Project Title:	GYSBI SHORE BASE	Scale:	Scaled to fit	Date:	2024.03.27
Project Location:	Houston District, Greater Georgetown	Request/Surveyed by:	SLC Ops.Man. Maintenance		*****
Drawing Title:	VESSEL PLATFORM/STAIRS	Drawing by:	A.Flatts	Drawing #:	VPS-A-101
		Checked by:	I.Baksh B.Murli	Page No:	01
		Approved by:		Appr. Date:

Project Title:	GYSBI SHORE BASE
Project Location:	Houston District, Greater Georgetown
Drawing Title:	VESSEL PLATFORM/STAIRS

NOTE: All weld connection must be full welds unless otherwise stated.

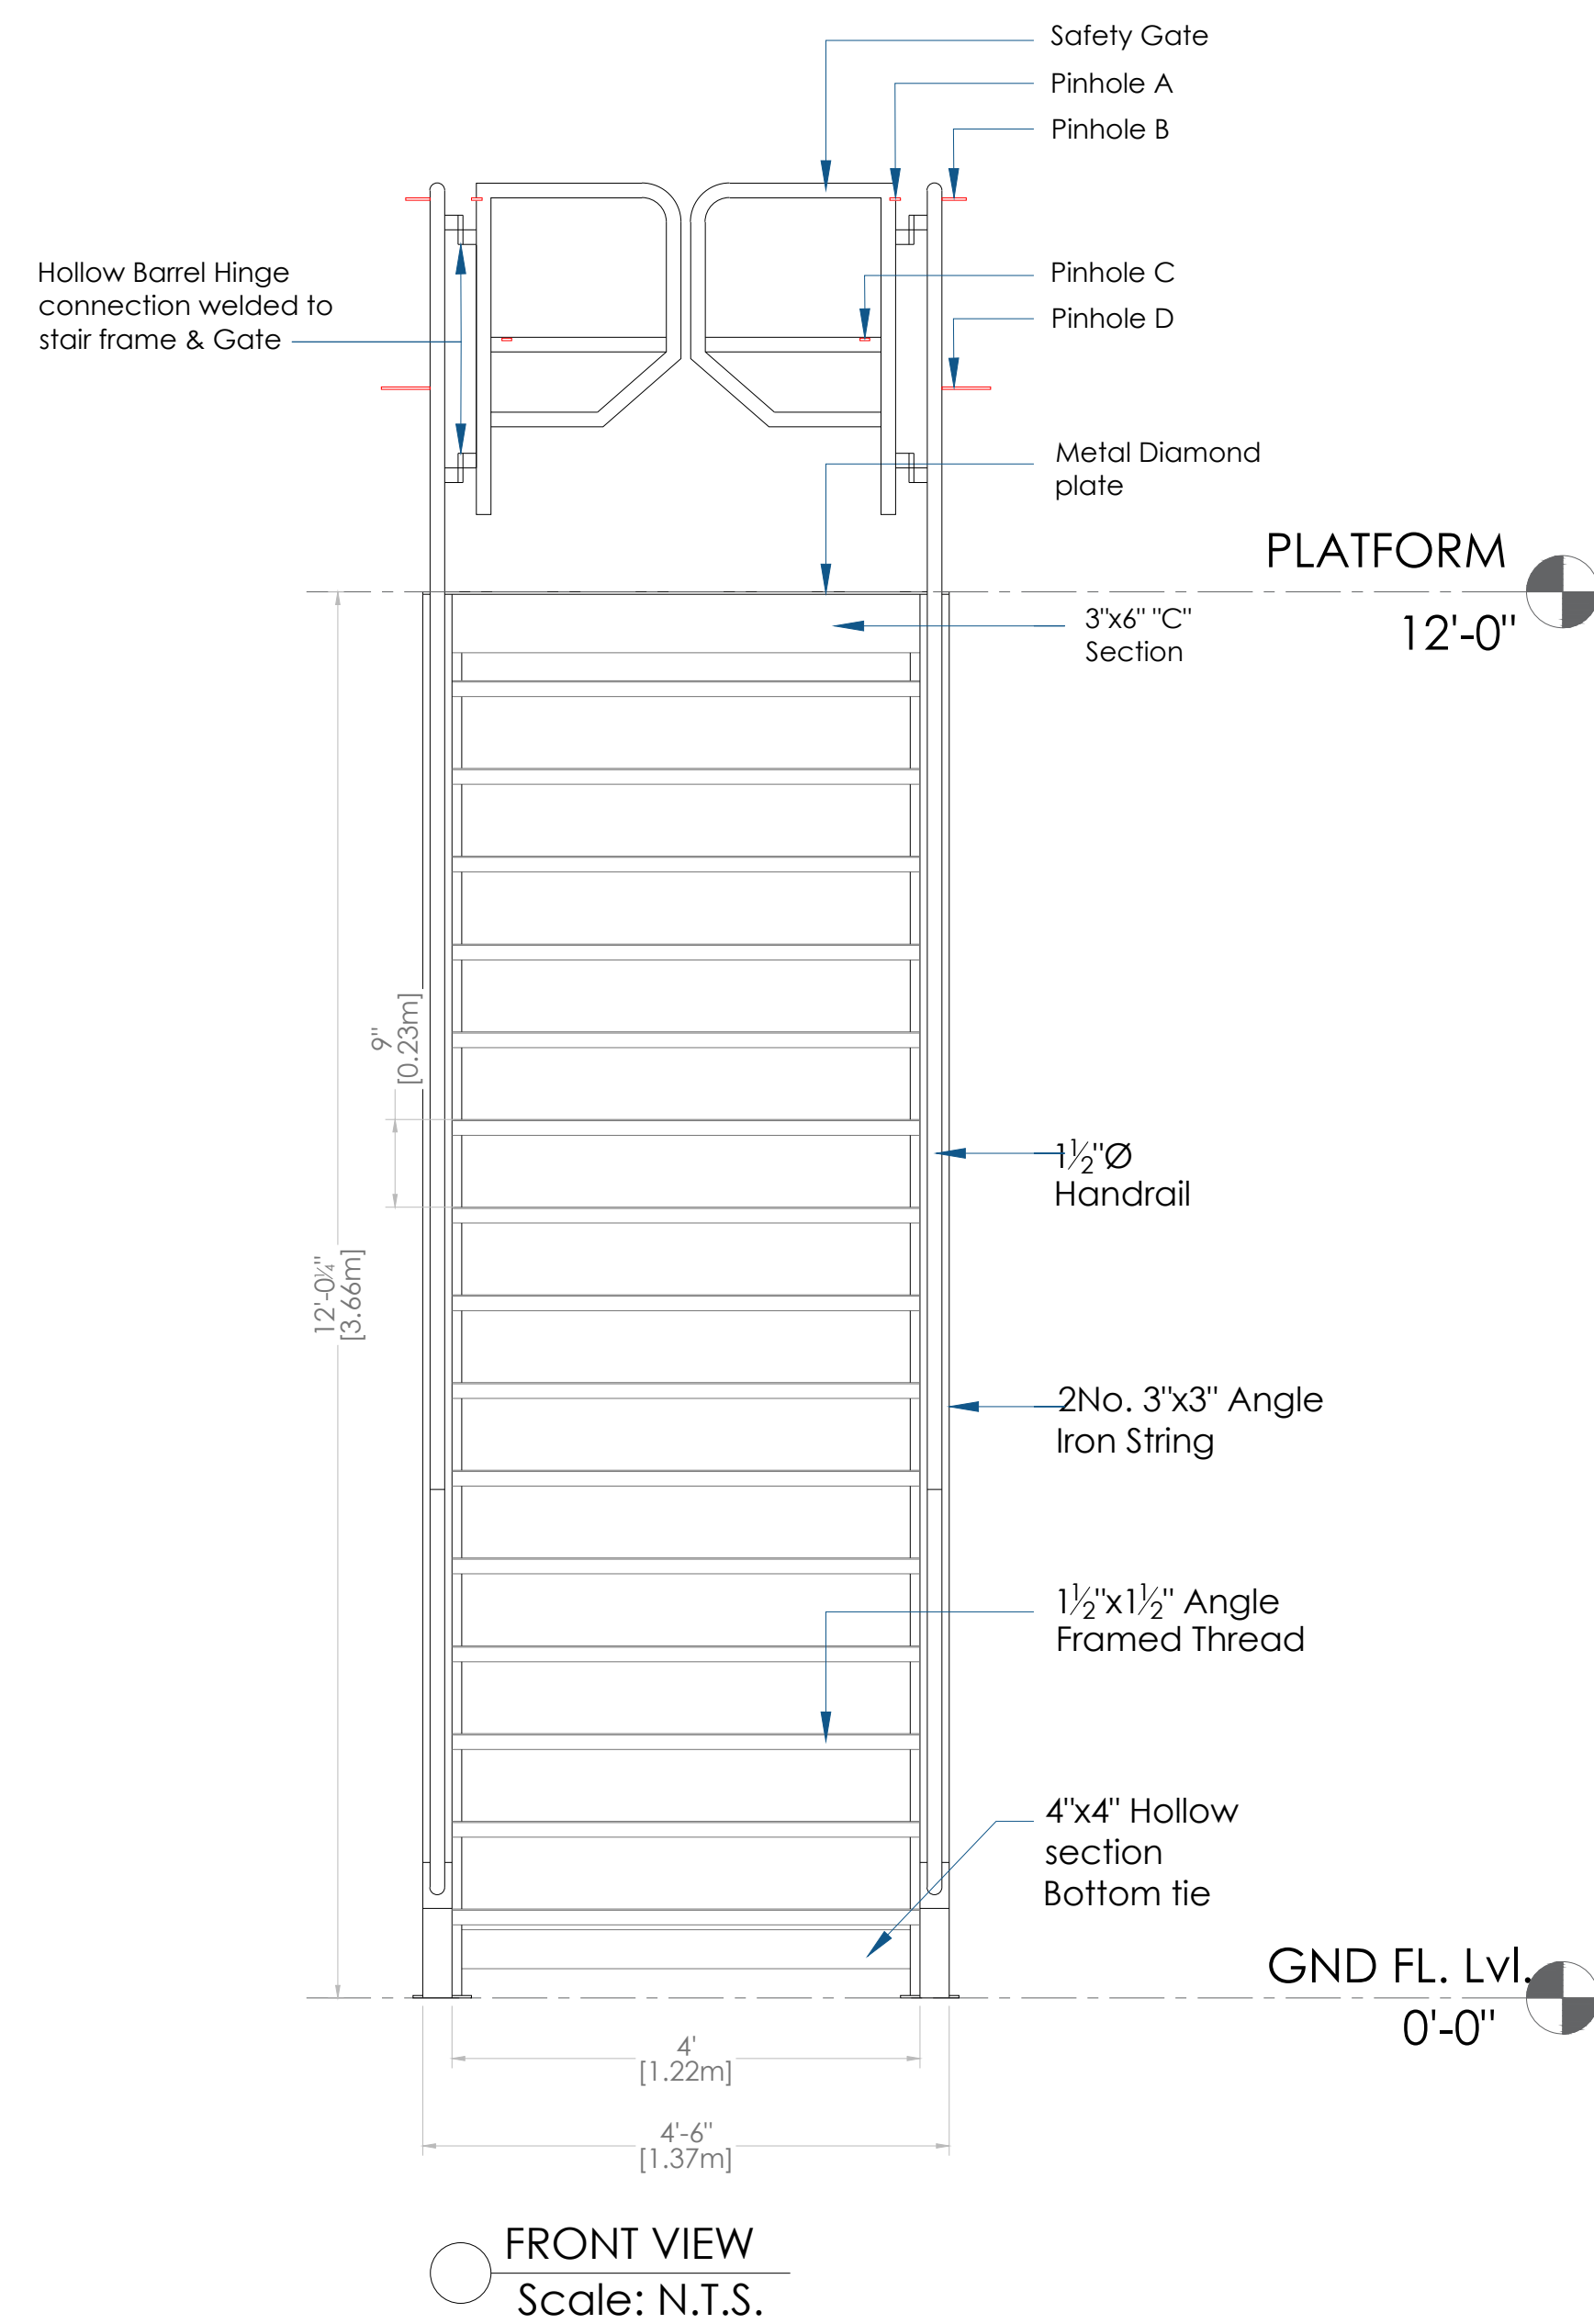
No:	REVISION	DATE:	CLIENT:
3	Stair lifting design update. 1" thk x 3" wide plate with 1.75" dia. lifting eye, welded to stringer frame and extended thru angled section about 5". Update reflects changes in "lifting eyes" on the stair stringer only. Other elements remain the same.	2024.03.26
